20-COA-0080
1430 S. 1st St.

Old Louisville Architectural Review Committee
Public Hearing

Bradley Fister, Historic Preservation Specialist
June 24, 2020

Elevations

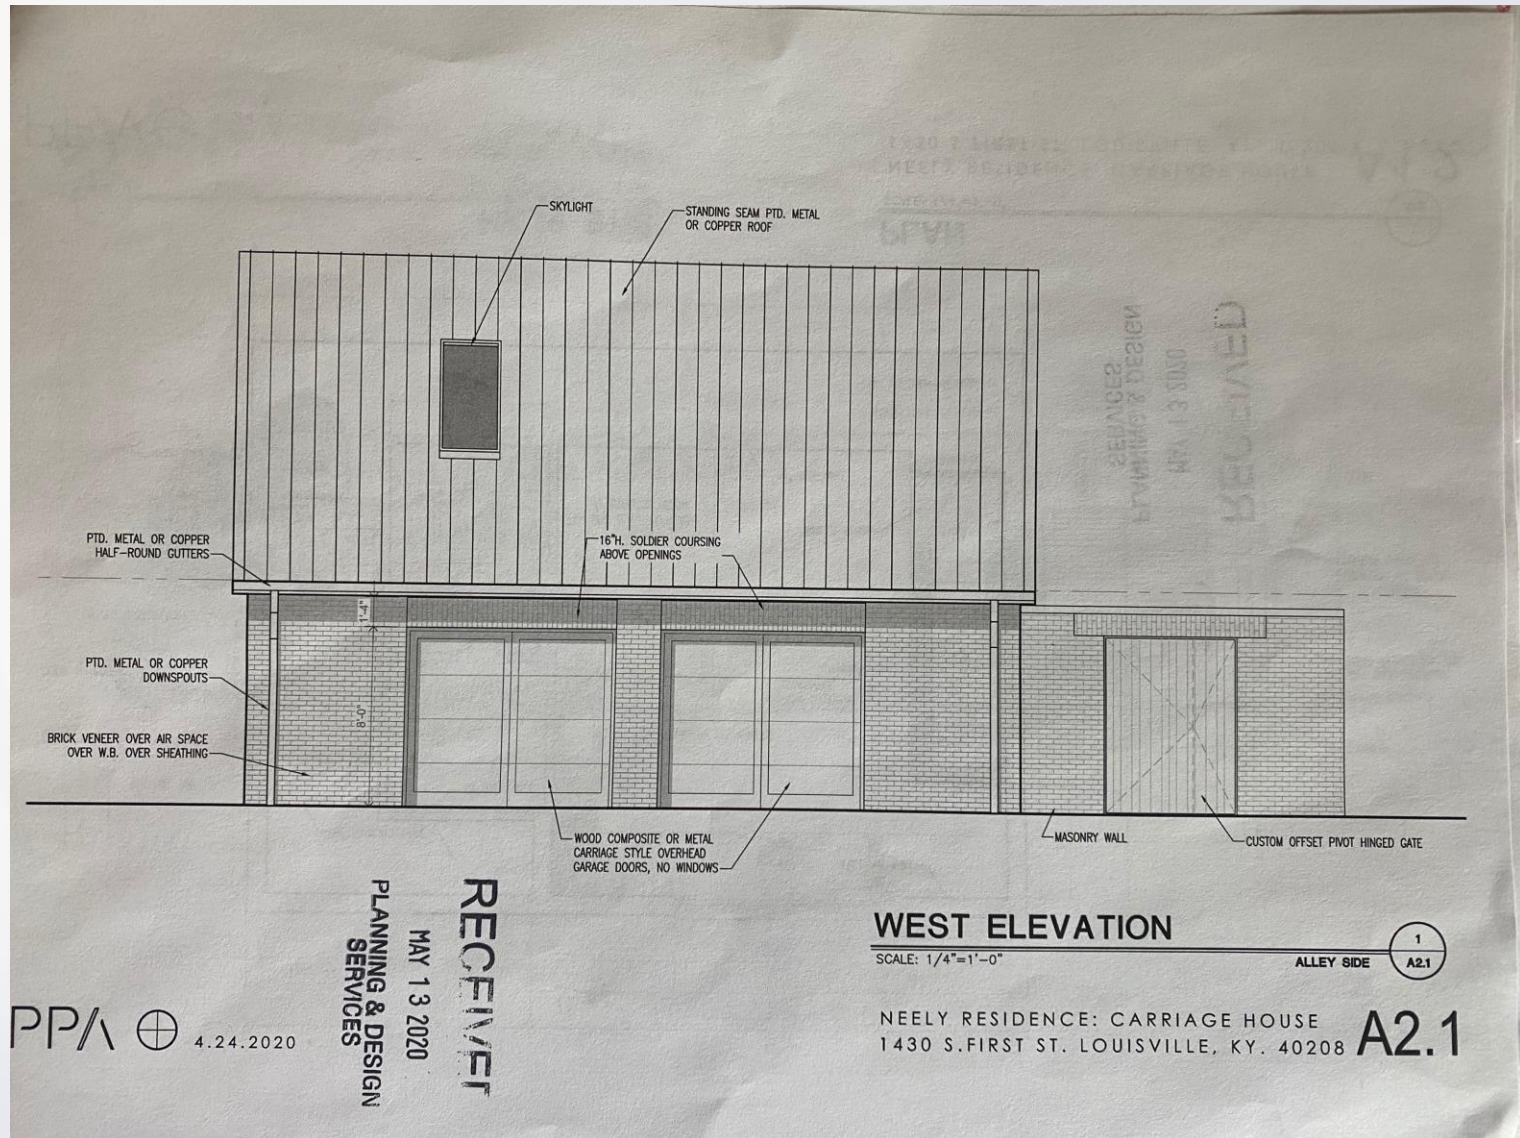
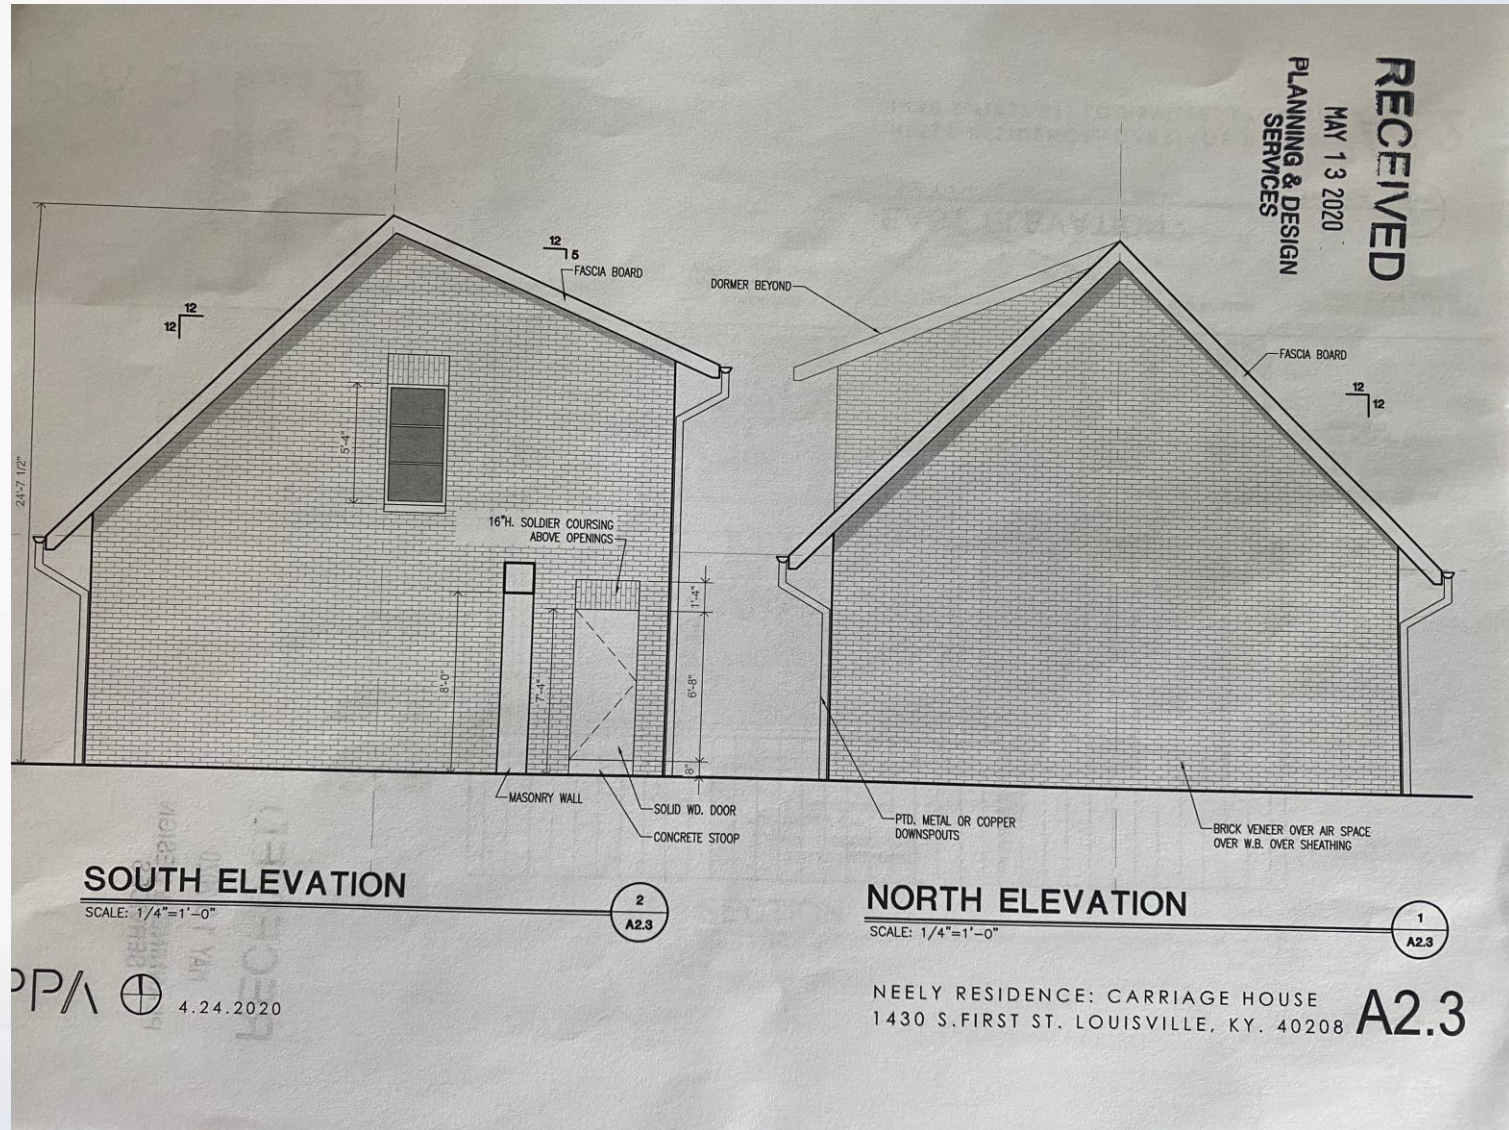
- The proposed carriage house generally meets the Old Louisville Design Guidelines for **Garage, New Construction-Residential, and Site**. The alleyscape has an eclectic mix of accessory structures and garages. The proposed structure meets the architectural context of the alley in location, size, massing, and scale and the materials are complimentary to those in the district. Staff recommends historic concrete mix should be used for the drive apron and parking pad.

- 1. The new construction shall conform to all other municipal regulations, including the Louisville Metro Land Development Code.
- 2. The applicant and/or their representative shall coordinate with staff to finalize their material choice for the roof prior to installation.
- 3. The applicant and/or their representative shall make provisions for screening and storing trash and recycling receptacles.

- 4. The applicant and/or their representative shall incorporate storm water management provisions into the design of new construction so that any related runoff will not adversely impact adjacent properties and nearby historic resources.
- 5. The applicant and/or their representative shall integrate mechanical systems into new construction in such a way that rooftops remain uncluttered and fixtures, such as air conditioning units and satellite dishes, are located on secondary elevations where they do not detract from the character of the site.
- 6. The new garage apron and parking pad shall be installed using historic concrete mix and shall not damage the alley or any existing curbing.

- 7. Any exterior lighting shall be submitted to staff for approval.
- 8. If the design or materials change, the applicant and/or their representative shall contact staff for review and approval prior to installation.
